# APPENDIX P2.M

## Comment Response Tables for Draft EAR/IS

RE: Webequie Supply Road Draft Environmental Assessment Report / Impact Statement Responses on Proponent Comment Response Table

**Document:** Draft Environmental Assessment Report/Impact Statement (EAR/IS)

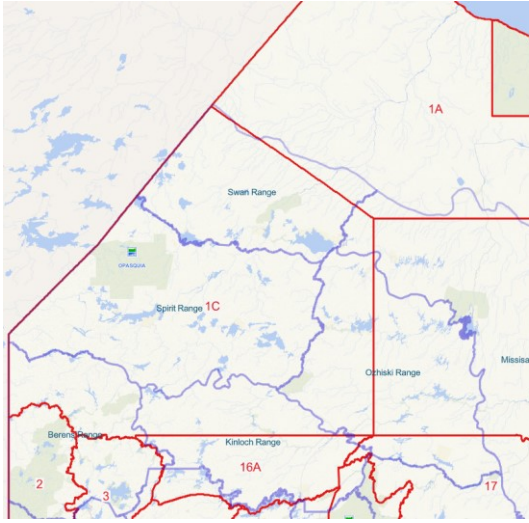
203.	Appendix F (Sections 11.1, 11.2, pages 582-599);	The Regional Study Area (RSA) for caribou (Boreal and Eastern Migratory populations) is limited to the Missisa and Ozhiski ranges for Boreal Caribou only. Given that 26/29 of the caribou collared within the Local Study Area (LSA) are likely to belong to the Eastern Migratory population (as suggested in Section 11.2.3.3.1 and 13.2.3.1.3), the RSA is likely undersized for informing indirect	Please consider adding migratory Caribou as a VC, and creating a new RSA for the migratory caribou, to reflect the most appropriate scope for which impacts should be considered.	A	4. Item will not be addressed as they are considered out of the	As discussed in the December 19th meeting with the WSR Project Team, the scope of impacts to Eastern Migratory (EM) caribou

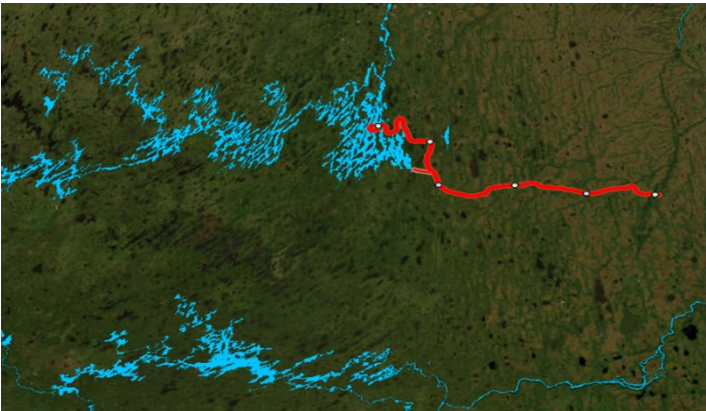
251.	12-495/ 12.8.1; 12- 497/ 12.8.1.4	<p>With regards to Sections 12.8.1 (Moose) and 12.8.1.4 (Injury or Death) the EA suggests that:</p> <ul style="list-style-type: none"> <li>- The “project’s net effects are predicted to be not significant with negligible to moderate scores for significance”. However, there are likely to be significant effects over the long-term due to increased predator and hunting access (as described above, in previous comments).</li> <li>- “With effective implementation of mitigation measures, mortalities due to collisions with vehicles, increased access, and changes to predator-prey dynamics, are unlikely to be significant.” This may be true for the construction phase and collisions with vehicles, but there are likely to be significant effects over the long-term due to increased predator and hunting access (as described in previous comments).</li> </ul> <p>Based on the recommended reevaluation of results mentioned in the previous comments, with regards to hunting, access and predator-prey dynamics, it is recommended that the significance of the net effects to moose also be reevaluated.</p>	Please reassess the significance of increased predator and hunter access net adverse effects, based on the recommended reevaluation of results mentioned in the previous comments.	A	2. Item will be addressed through addenda to Final EAR/IS submission that will be completed by the end of the twenty-three-week review period	B. Satisfied for now but will need to see final EA.

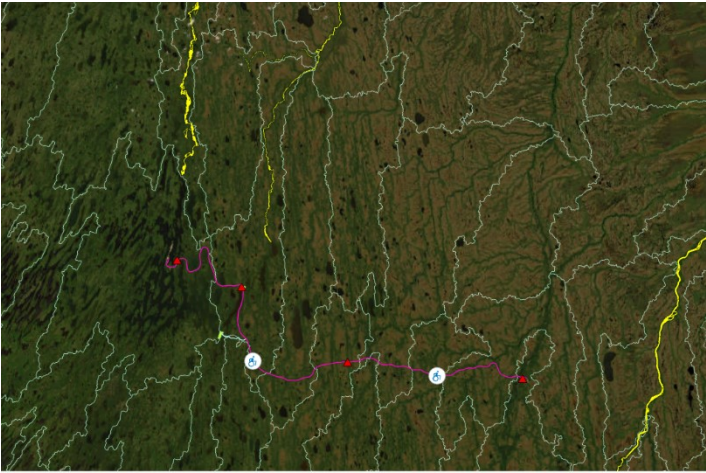
252.	12-497/ 12.8.1.4; 12-497/ 12.8.1.4	<p>Section 12.8.1.4 (Injury or Death), with regards to moose, indicates:</p> <p>a) “the significance score for increased access is 4 and 10 for the construction phase and operations phase of the Project, respectively. These indicate a negligible effect resulting from the construction phase and a low effect resulting from the operations phase.” The score and effect for the operations phase seem inconsistent.</p> <p>b) “The significance score for changes to predator-prey dynamics is 8 and 9 for the construction phase and operations phase of the Project, respectively. These indicate a low effect resulting from both the construction phase and operations phase.” The score and effect for the operations phase seem inconsistent.</p> <p>The scoring system assigns values across 8 key criteria, but not all criteria are weighted equally. Some have more scoring categories, making them more influential in determining the total score. As a result, achieving a total score of 16 or higher (which indicates a significant net or cumulative effect) is highly unlikely.</p> <p>For example, to predict a significant net effect on moose, a score of 4 must be assigned in at least one of the following key criteria: Magnitude, Geographic Extent, or Context. Since moose did not receive a score of 4 in any of these areas, the overall effect on moose is rated as Moderate and Not Significant.</p> <p>However, Indigenous knowledge and scientific literature suggest that sensory disturbance, increased access, and changes to predator-prey dynamics are likely to have significant impacts on moose within the Local Study Area (LSA, 11 km) once the road is operational. The current scoring system does not adequately reflect this likely outcome.</p>	In the Final EA, MNR recommends revisiting the scoring system. For example, by reclassifying scores in the 11–15 range (Moderate) as indicating significant effects.	A	2. Item will be addressed through addenda to Final EAR/IS submission that will be completed by the end of the twenty-three-week review period	B. Satisfied for now but will need to see final EA.
